THE PORT AUTHORITY OF NY & NJ

ADDENDUM #2

**TO PROSPECTIVE BIDDER(S) ON CONTRACT # WTCR – W30-2011-31
WTC REDEVELOPMENT – WTC TOWER 2 PLAZA INTERIM IMPROVEMENTS**

Tower 2 Plaza Interim Improvements
SK-7
2/10/2015

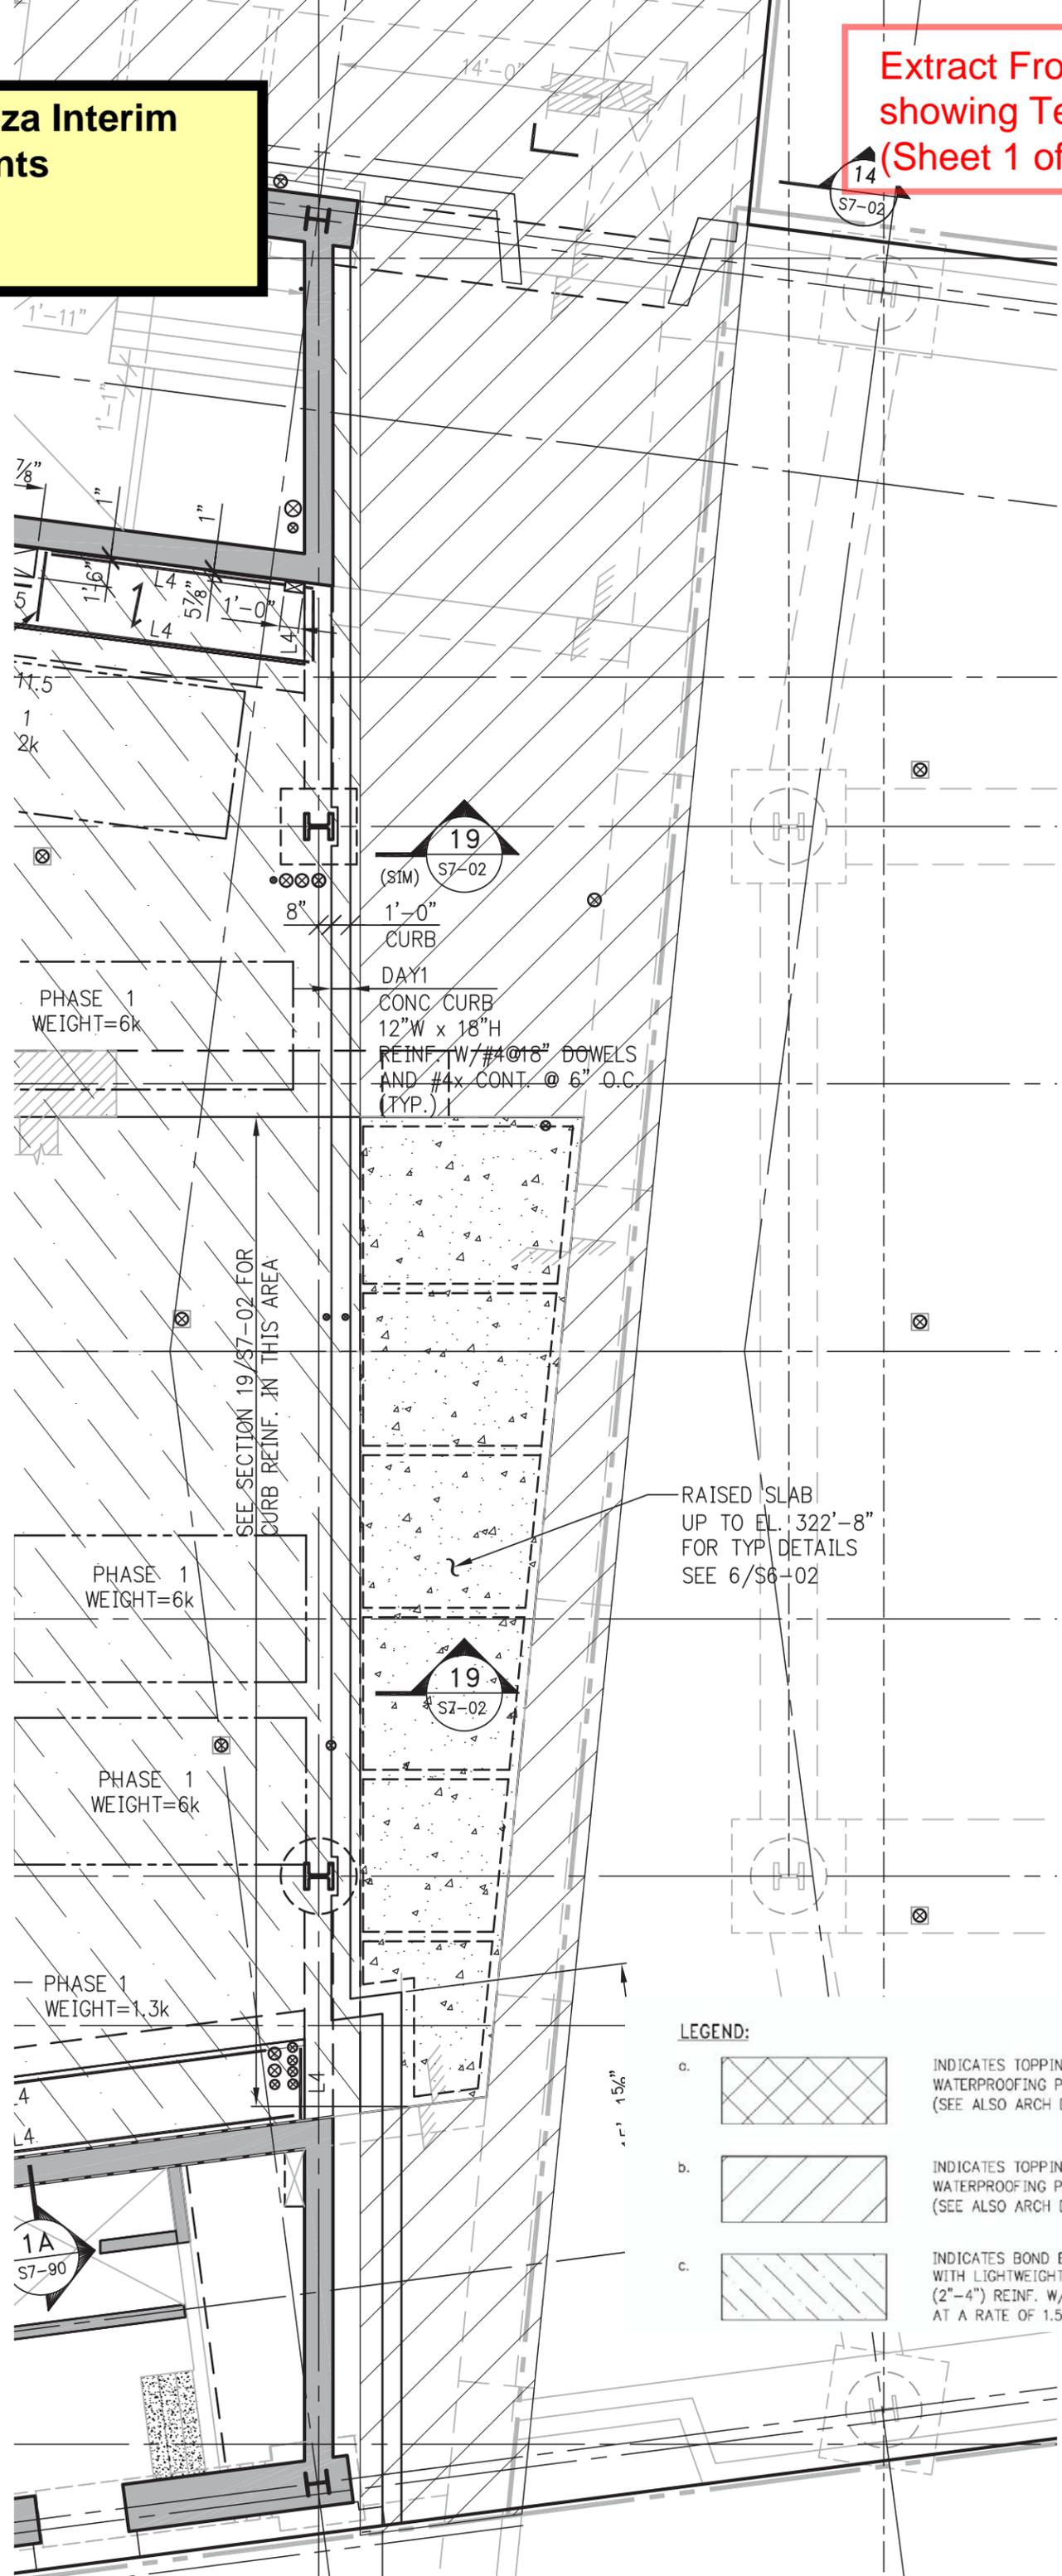
Question #4	Sheet L-02 – Please provide greater detail as to what we are required to demolish (i.e. 6” reinforced concrete or 3” asphalt, etc.) Please also provide dimensions and grid lines on this drawing so that the work can be overlaid onto other drawings.

Question #43	2/L-02 DEMOLITION DETAILS shows the "EXISTING AREAS TO BE REMOVED." Please advise of what material is this removal? Please advise the thickness and width.

Answer #4	Refer to attached Sketches - SK-7, SK-8, & SK-9, dated 02/10/15, pertaining to the area between the slurry wall and the face of the building. For all other areas, Contractor is to assume existing 6" layer of crushed stone and soil.

Answer #43	Refer to attached Sketches - SK-7, SK-8, & SK-9, dated 02/10/15, pertaining to the area between the slurry wall and the face of the building. For all other areas, Contractor is to assume existing 6" layer of crushed stone and soil.

SK-8

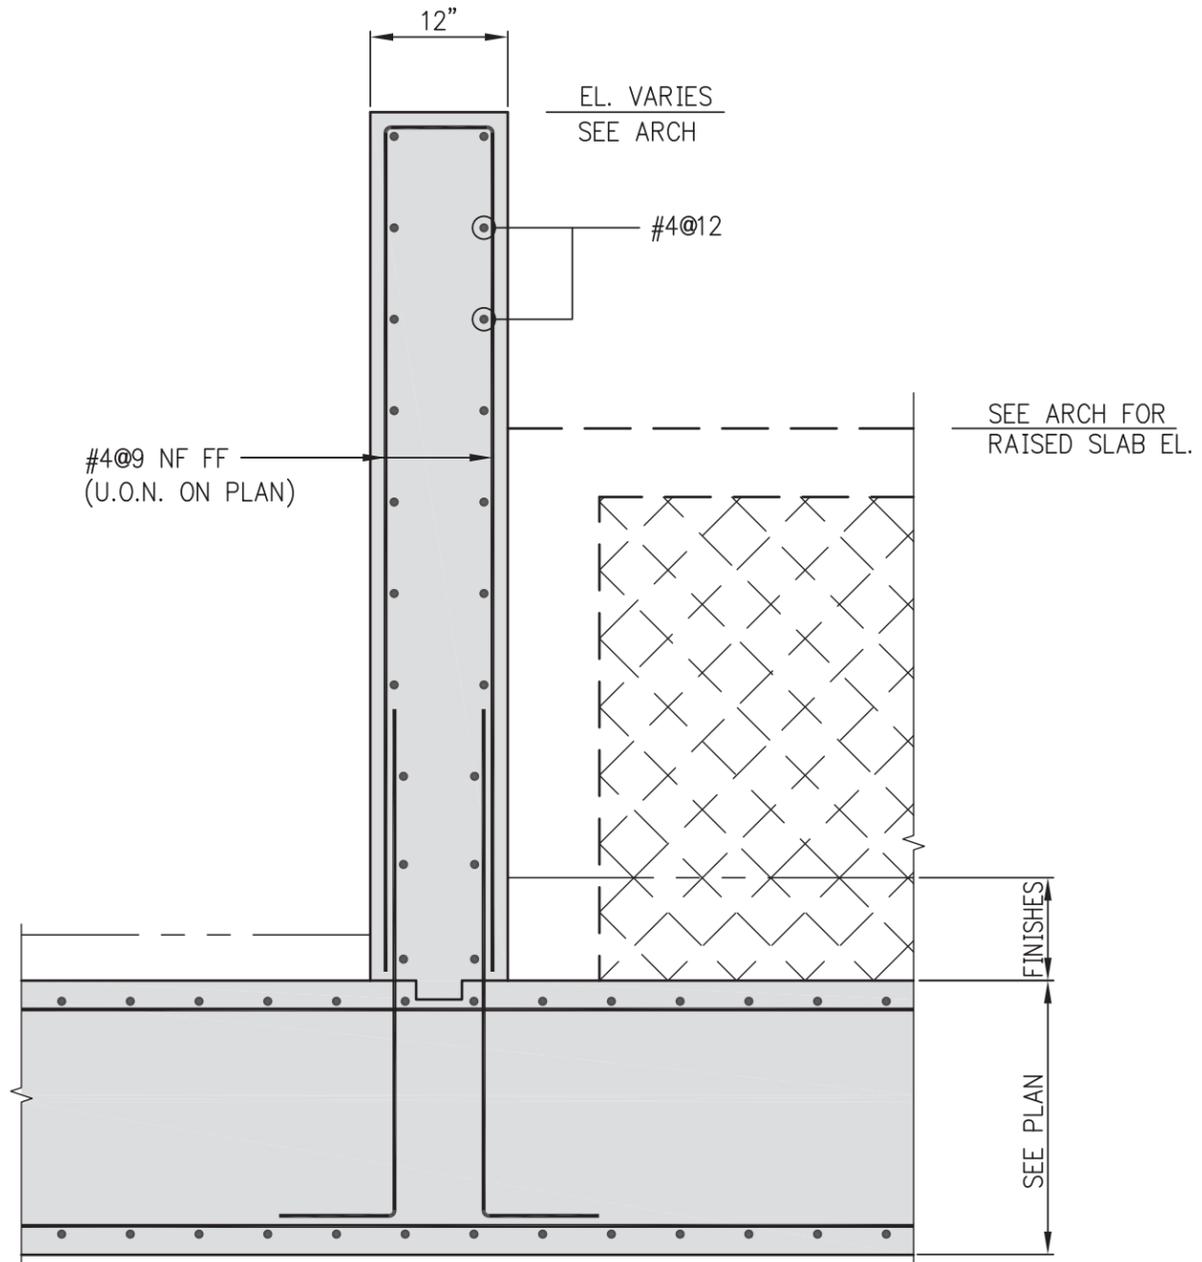
Question #44	3/L-02 DEMOLITION DETAILS also shows the "EXISTING AREAS TO BE REMOVED" and there seems to be a depressed area in comparison with 2/L-02. Please advise of what material is this removal? Please advise the thickness and width.

Question #45	Drawing L-02 contains section 3/L-02 DEMOLITION DETAILS shows the "EXISTING AREAS TO BE REMOVED." As in 1. above Please advise of what material is this removal? It would appear that it would be soil and is the top of this material accurately represented by the section 3/L-02?

Answer #44	Refer to attached Sketches - SK-7, SK-8, & SK-9, dated 02/10/15, pertaining to the area between the slurry wall and the face of the building. For all other areas, Contractor is to assume existing 6" layer of crushed stone and soil.

Answer #45	Refer to attached sketches - SK-7, SK-8, & SK-9, dated 02/10/15, pertaining to the area between the slurry wall and the face of the building. For all other areas, Contractor is to assume existing 6" layer of crushed stone and soil.

Extract From Ground Floor Plan showing temp slab build up (Sheet 3 of 3)

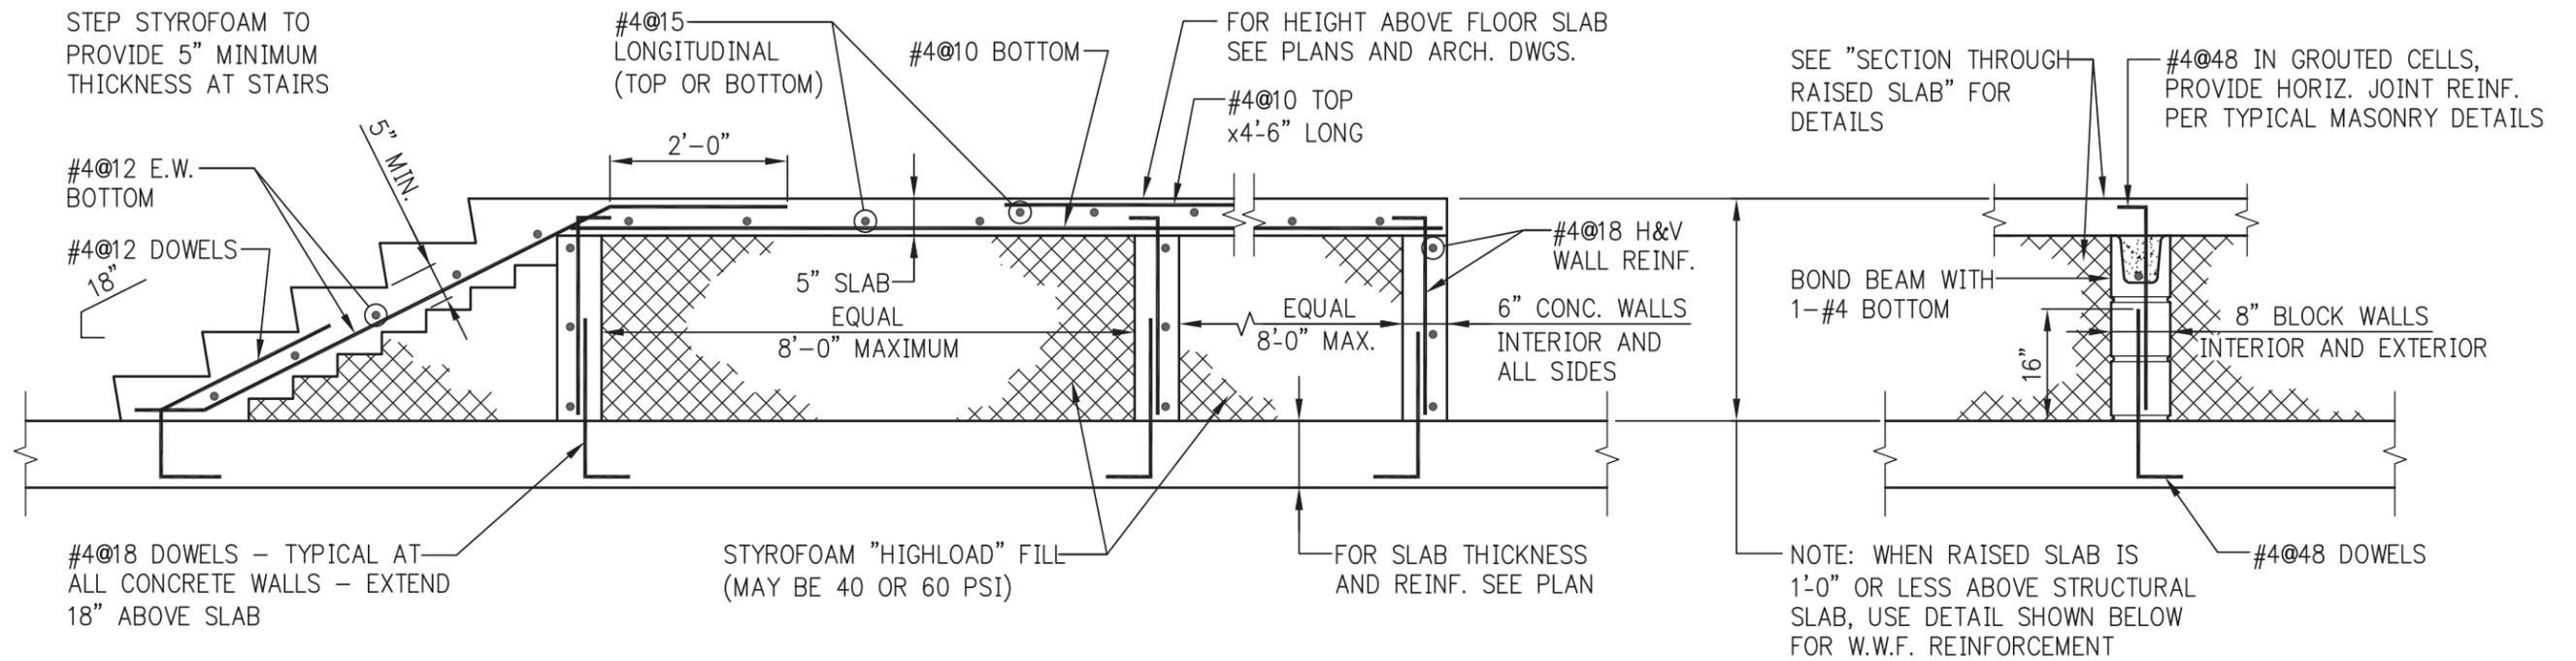
Answer #40	Furnish and install 2#18AWG cables.
Question #41	Drawing L-02 at the LEGEND shows a diagonal line symbol indicating AREA TO BE DEMOLISHED. At the lower left side 1 DEMOLITION PLAN shows the diagonal legend symbol and also shows a 'cross-hatched' legend symbol. Approximately halfway up the PLAN, on the left side, there is a note with an arrow pointing to the cross-hatched area of the DEMOLITION PLAN. The note says DEPRESSED SLAB AREA SEE 2/L-02. But 2/L-02 does not show a depression, 3/L-02 seems to show a depression. Should the note say DEPRESSED SLAB AREA SEE 3/L-02?

Answer #41	Correct, the note should reference 3/L-02.
Question #42	Is the cross-hatched symbol a different type of removal than the diagonal line legend for removal? If so, please advise what is the difference?

Answer #42	Refer to attached sketches - SK-7, SK-8, & SK-9, dated 02/10/15, pertaining to the area between the slurry wall and the face of the building. For all other areas, Contractor is to assume existing 6" layer of crushed stone and soil.

WATERPROOFED SLEEVE THROUGH WALL
WITH WATERPROOFING

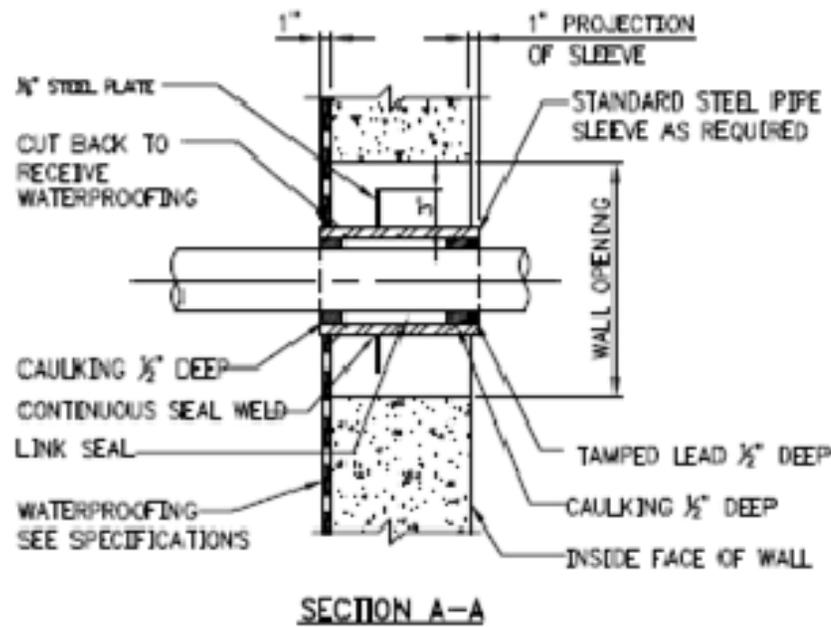
Question #17	Can we core drill the foundation wall on the east side in the mechanical space to get below grade for electrical conduits? If not core drill, can we penetrate the steel wall to exit the building on the east side? Please clarify.

Answer #17	Yes, but all core drilling will need to be coordinated and approved by the Port Authority. Contractor will be required to provide appropriate waterproofing pipe seal in accordance with sketch SK-10 dated 2/11/15.
